SERVICE BULLETIN

NO. 1103E

Date: June 5, 2014

ENGINE MOUNT INSPECTION

Figure 1
Engine Mount Inspection Areas

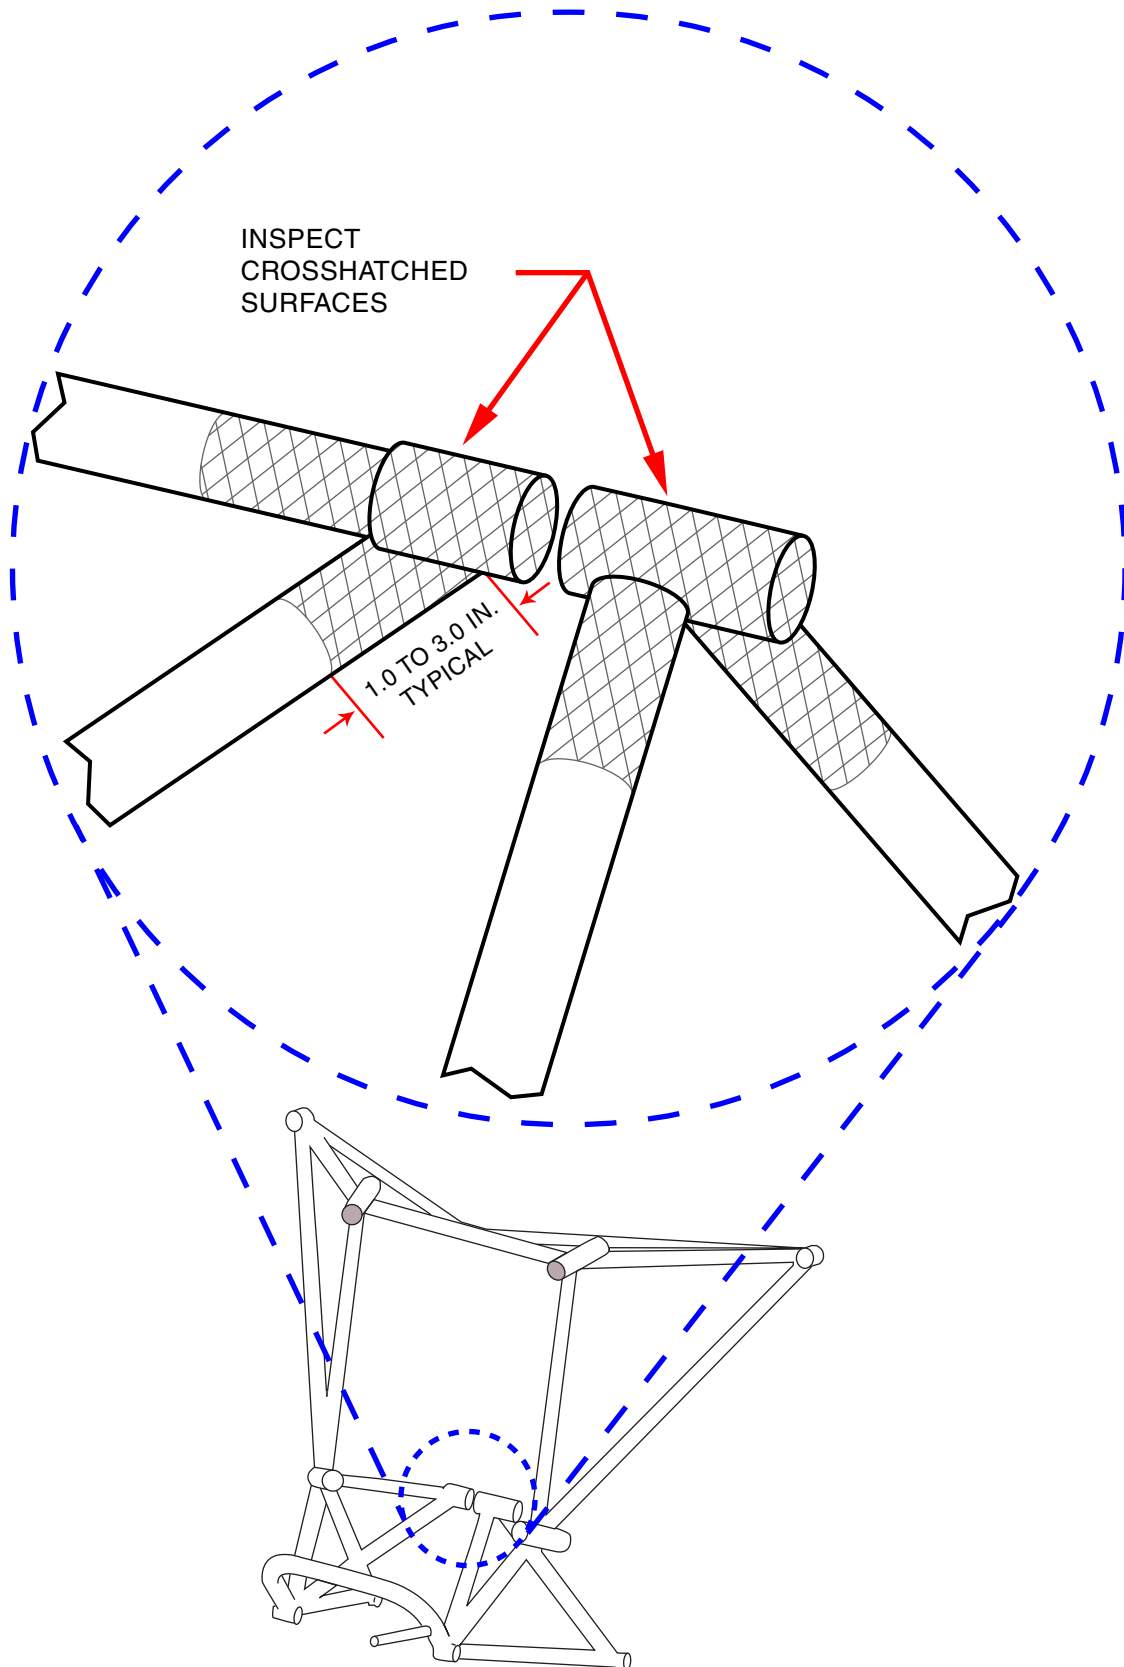
Cracks may develop in the area of the nose gear actuator attach feet on the engine mount (see Figure 1). This condition can occur when the nose landing gear is subjected to excessive loads due to hard landings, rough field operations, excessive speed turns, improper airplane towing (sudden, aggressive starts and stops), or other improper operations.

1. Clean the engine mount actuator attach feet area.
2. Completely remove all of the paint or Dinitrol AV8 and AV30, if the paint was previously removed and covered with Dinitrol AV8 and AV30, from the inspection area (refer to Figure 1).

3. Perform fluorescent penetrant inspection of the nose gear actuator attach feet for cracks per AC 43.13-1B, Chapter 5, Section 5. Inspect the surfaces identified in Figure 1, with specific emphasis on welded areas.
4. If a crack is discovered, the engine mount must be replaced prior to further flight (refer to Table 1).
5. If no cracks are found, continue the repetitive inspection per the compliance time above.
6. Clean the feet and apply a two-coat corrosion prevention compound (CPC) to the area where the paint was removed. This two-coat CPC consists of Dinitrol/Ardrox AV8 as a primer coating and (after the AV8 has dried) Dinitrol/Ardrox AV30 as a top coating.
7. Make an appropriate logbook entry of compliance with this service bulletin for each repetitive inspection.

Figure 2
Engine Mount Hardware Installation - P/N 89137-043 Only

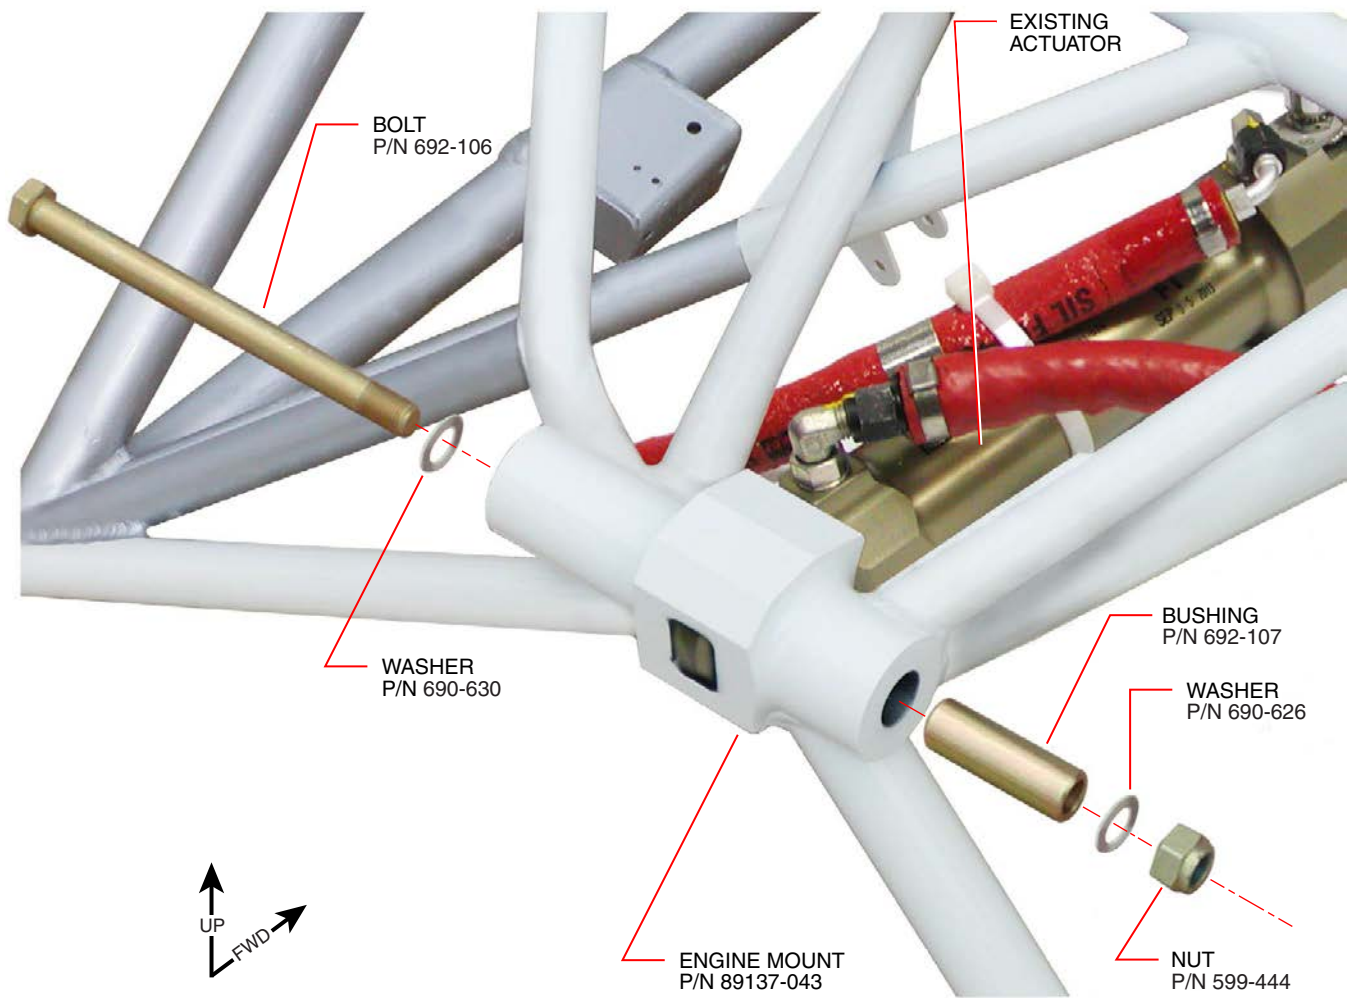
SB 1103E announces a new replacement engine mount, P/N 89137-043, for PA-46-350P and PA-46R-350T airplanes only, which, when installed, eliminates the recurring inspection.

NOTE: For PA-46-350P Mirage and PA-46R-350T Matrix models only, Piper has developed a corrective action to eliminate the recurring inspection requirement, whether or not a crack has been discovered. If the engine mount on an affected PA-46-350P or PA-46R-350T model is replaced with P/N 89137-043 (Part II), the repetitive inspection requirement is eliminated.

1. If cracks are found on the engine mount, order the appropriate replacement engine mount found in Table 1, and hardware, as required.
2. Install the new engine mount according to procedures in the applicable Piper airplane maintenance manual. For PA-46-350P Mirage or PA-46R-350T Matrix model airplanes only: fasten the aft end of the nose gear actuator to the engine mount using the hardware arrangement shown in Figure 2. Torque nut according to requirements in section 91-10-00 of the applicable Piper airplane maintenance manual. At all other locations, hardware in serviceable condition may be reused.
